**AGENDA
FARRAGUT MUNICIPAL PLANNING COMMISSION**

**November 16, 2017
7:00 p.m. Farragut Town Hall**

**SUBJECT: STAFF COMMENTS ON THE RESUBDIVISION PLAT TO
CREATE THE PARCEL THAT WILL BECOME THE PLANNED
COMMERCIAL DEVELOPMENT AT S. WATT ROAD AND
KINGSTON PIKE**

4 TYPICAL SECTION - ROAD 'A'
C-10

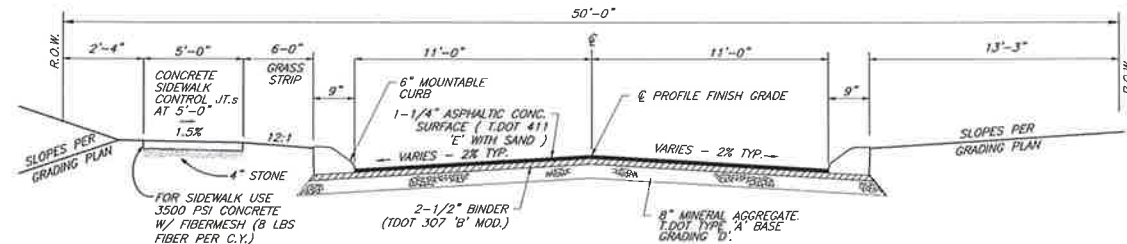
- 8) FUD must sign off on Sheets 8-10;
- 9) Please consider providing for the ability to add street trees by increasing the grass strip width from 3 to 6 feet and modify the plans accordingly, including detail 4 on Sheet 10. This is a standard that the Town is moving toward and will possibly be requiring in the

- 17) The plans show the street to have total width of 22 feet. Our standard is 26 feet from face of curb to face of curb. The required 26' width is required to allow on-street parking on each side of the roadway, while still providing width for emergency vehicles to pass. Staff will defer to the Town's Fire Marshall if he believes variance request is reasonable on such a short street;
- 18) Radius returns at Old Stage Road should be completed with 6-30 curb & gutter. Please provide detail, and use minimum 6" gutter depth;
- 19) Minimum pipe size is 18" diameter. The 15" HDPE pipe under trail on Lot 4 should be 18" RCP;
- 20) Please provide sheets showing gas, electric, telephone and cable;
- 21) Please provide copy of NOC;
- 22) Please submit irrevocable letter of credit for erosion control for \$14,000; and
- 23) Please submit Drainage Fee of \$210.

9. We have incorporated a 6' grass strip into the layout per comment. Please see Sheet C-1 and Detail 4, Sheet C-10.
10. At this time, the Developer is opting not to construct a central island within the cul-de-sac.

17. The revised road section shows a mountable curb in an effort to satisfy the pavement width concern. Please see Details 4 and 5 on Sheet C-10.
18. Revised per comment. Please see Sheet C-1.
19. Revised per comment. Please see Sheet C-3.
20. We are awaiting plans from all utility providers. We will include their layouts in the next submittal.
21. We have received comments from TDOT. They are requiring an averaged 60' buffer, which has been shown on the resubmittal. We have resubmitted the corrected drawings to TDEC and will provide their NOC upon receipt.
22. LOC to be provided under separate cover.
23. Drainage Fee to be provided under separate cover.

5 TYPE 'B' (MOUNTABLE) CURB AND PAVEMENT DETAIL
C-10

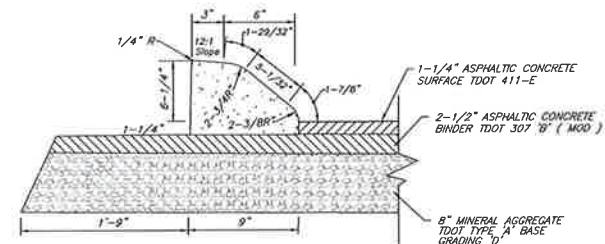
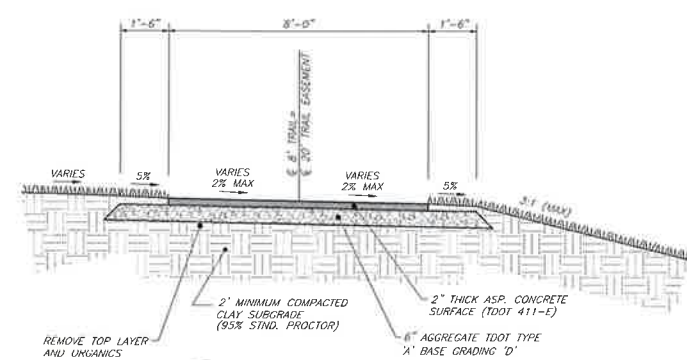
- 1) Please provide a fire hydrant at the entrance to the development;
- 2) Please provide fire hydrant flow data for the existing fire hydrant closest to the proposed new tap for service;
- 3) Roadway widths are not adequate. One option is providing a mountable curb/gutter combination to extend drivable width surface;

1. I would like to discuss this requirement at your earliest convenience.
2. We have requested fire flow data from FUD but have not received it to date. I will update Sheet C-1 after receipt of the flow information and resubmit.
3. The revised drawings propose a 6" mountable curb in lieu of the 6" non-mountable per comment. Please see Sheet C-1 and Details 4 and 5 on Sheet C-10.

10 STREET NAME SIGN DETAIL
N.T.S. SEE STREET NAME SIGN NOTES

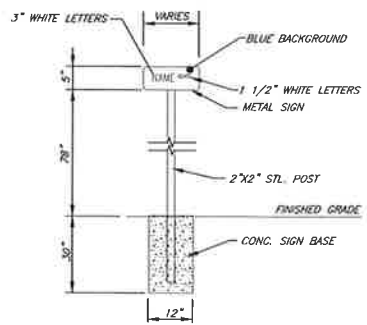
- 6) Please label the sinkhole lip elevation and include elevations for the contour lines;
- 7) Please clarify that the street lights will have break away posts;

7. Revised per comment. Please see Detail 11, Sheet C-11.
8. The water and sewer drawings have been submitted to FUD for their review. We are awaiting their comments or approval. We will submit FUD-signed drawings with our next submittal.

OVERALL SITE PLAN
Scale: 1" = 10'-0"

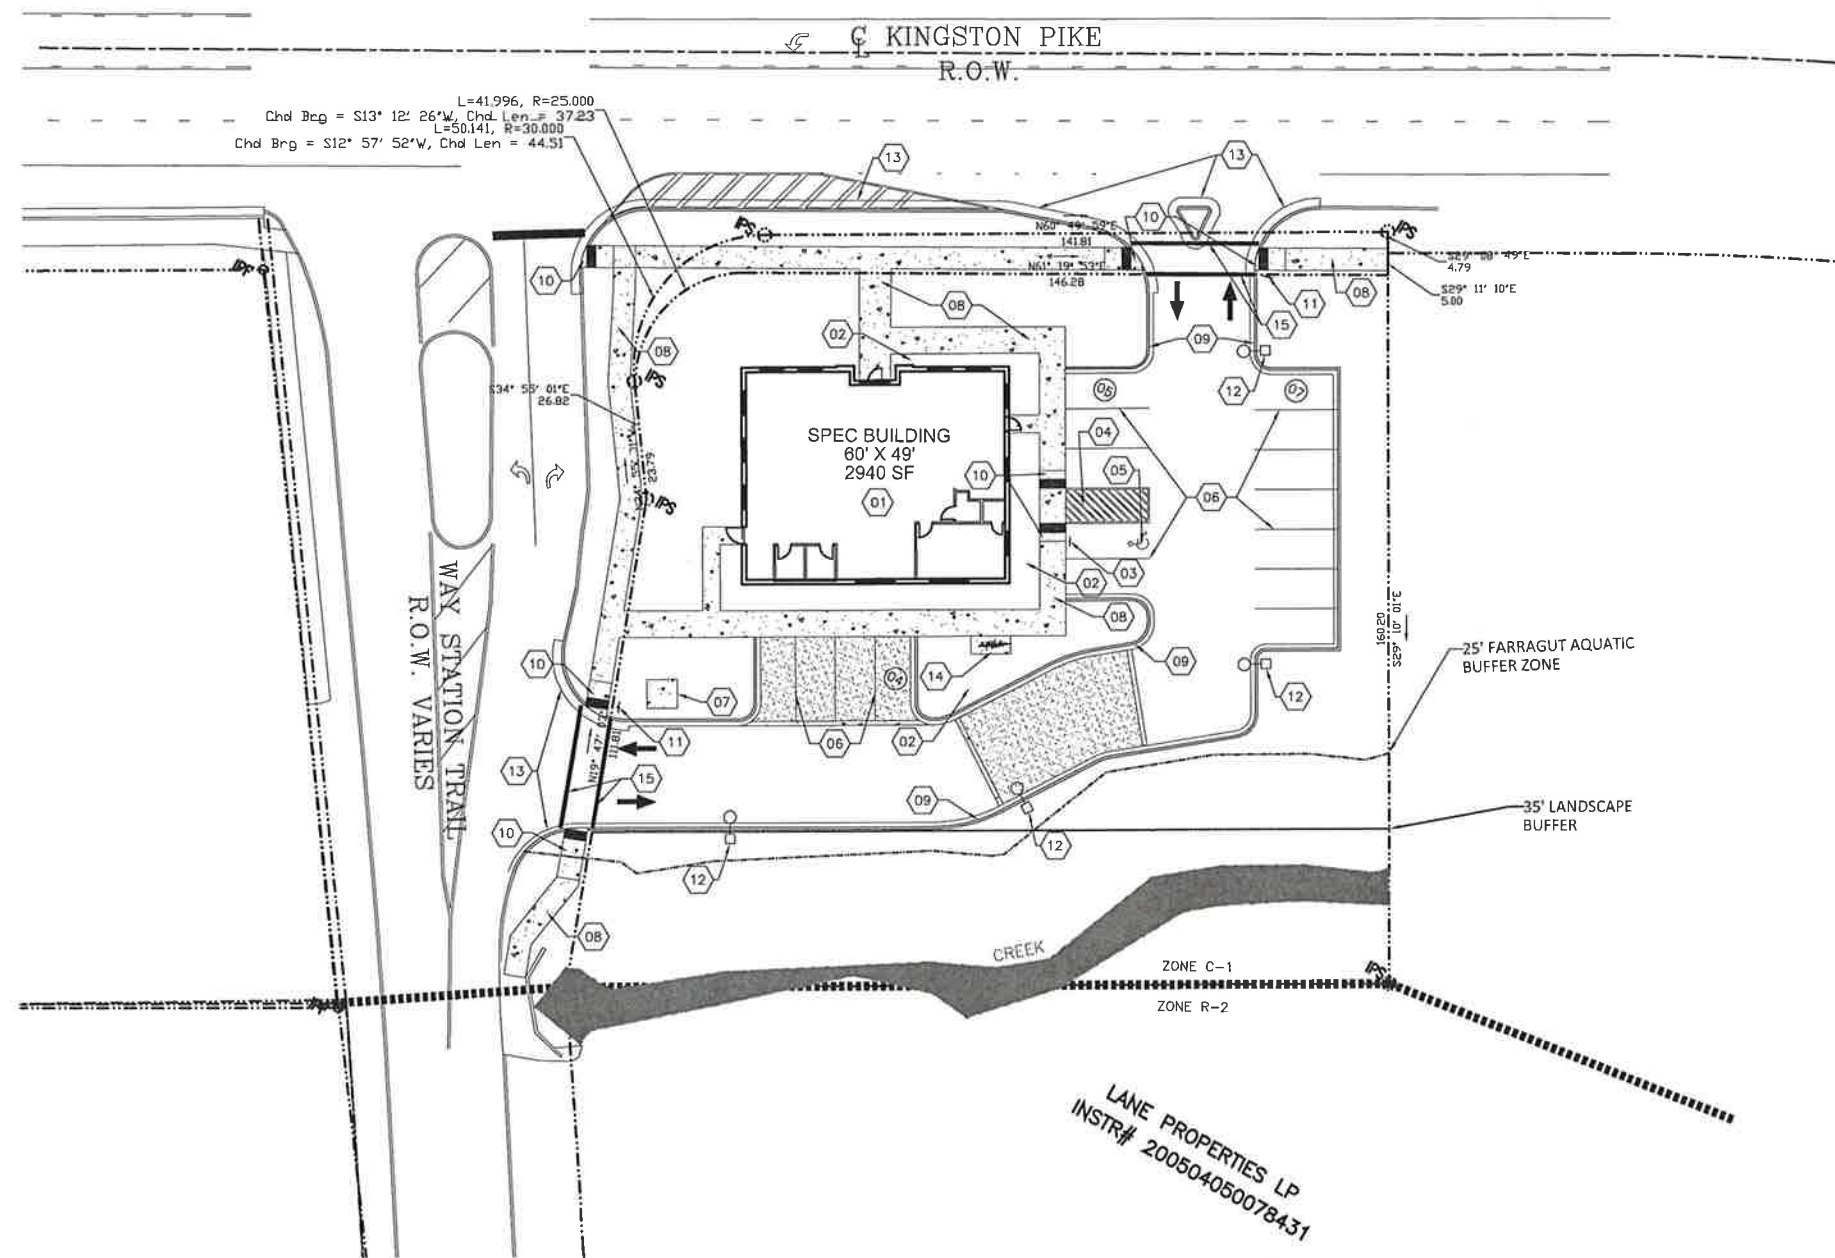
- 6) The applicant has not yet submitted a required lighting plan. There is also a note (note 12) on the overall site plan sheet (sheet C3.0) that references a light pole and two drawings that are not included in the submitted materials and that we assume are related to the pending lighting plan;

- 9) Note 7 on the overall site plan sheet (sheet C3.0) references an electrical transformer pad that does not appear to be shown on the plan;
- 10) The surveyor's stamped seal is not signed across its face on the property survey sheet;

8. We will eliminate the MFE note on drawing C4.0. This was missed.
9. We have shown the transformer pad on all plan sheets.
10. We have included a signed Survey with this submittal.

SITE GRADING PLAN
Scale: 1" = 20'-0"

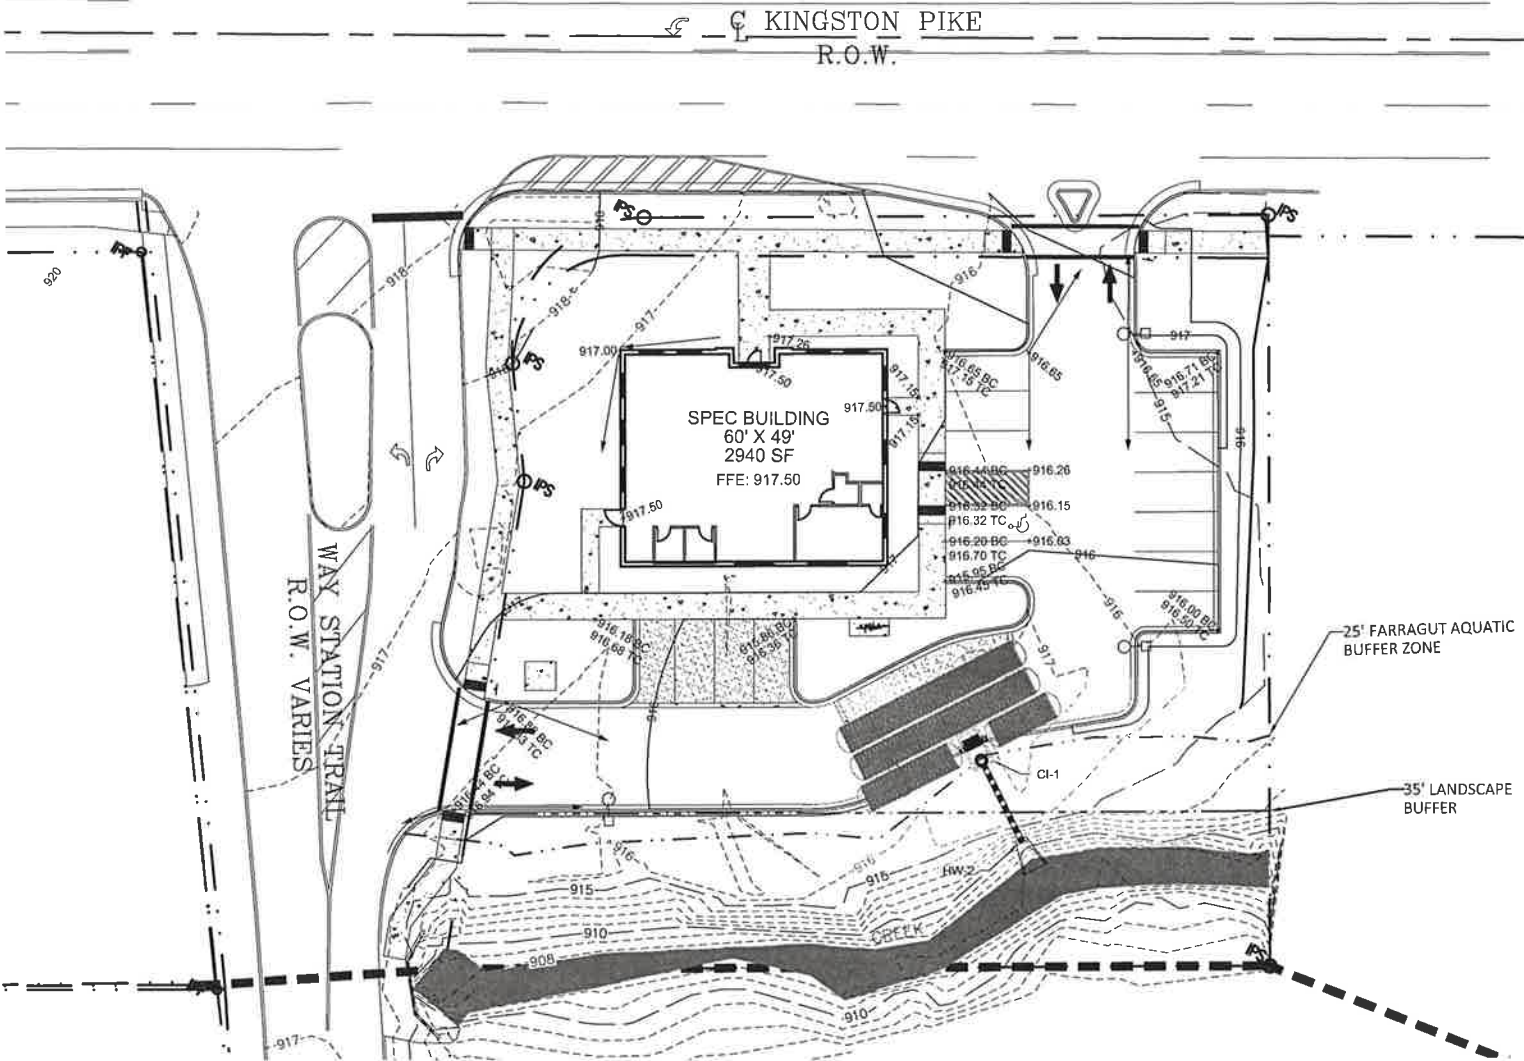
- 8) The building's Finished Floor Elevation (FFE) is shown as being below the noted Minimum Floor Elevation (MFE) on sheet C4.0. [Note: the creek is an "unmapped stream" with respect to the Town's Floodplain Management Regulations and therefore is not subject to a MFE];

3) Undefined Drainageway

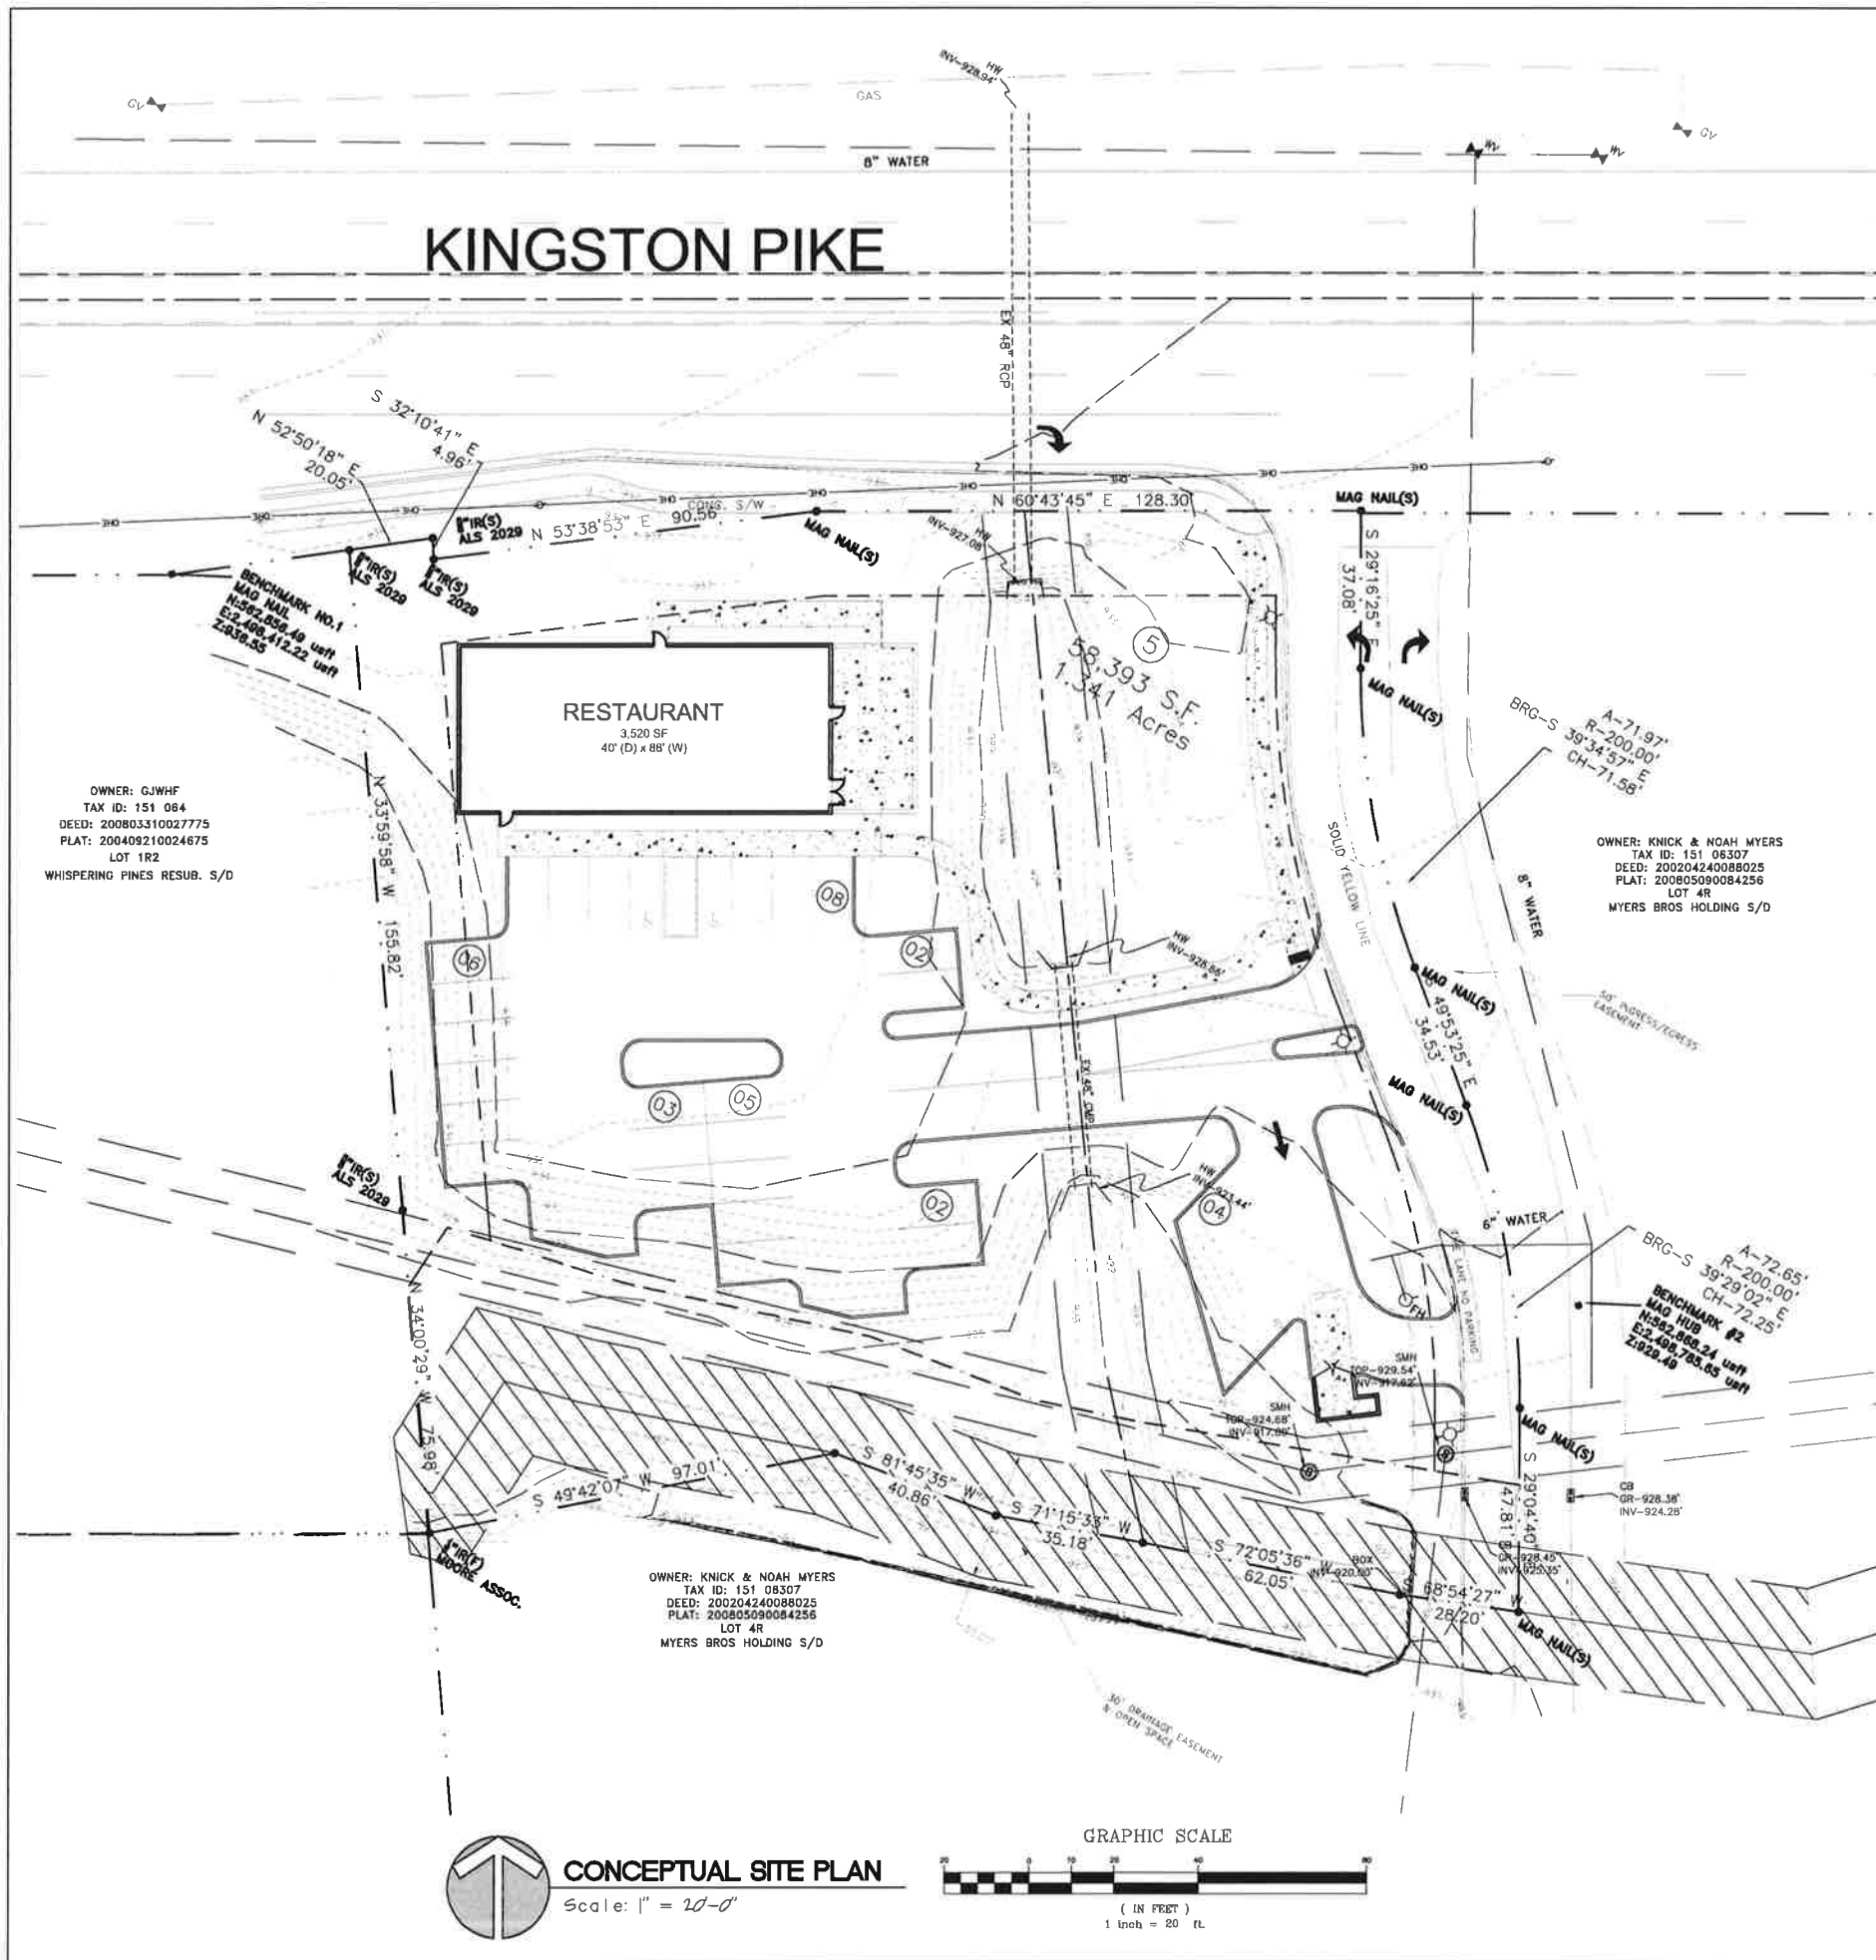
As noted above, there is a drainageway running through the eastern third of the property. This drainageway was observed carrying what appeared to be a regular flow of water in a defined channel, and will need to be evaluated by a Qualified Hydrologic Professional (QHP) before site construction activities are permitted. Its location on the site could further impact overall site design and construction activities.
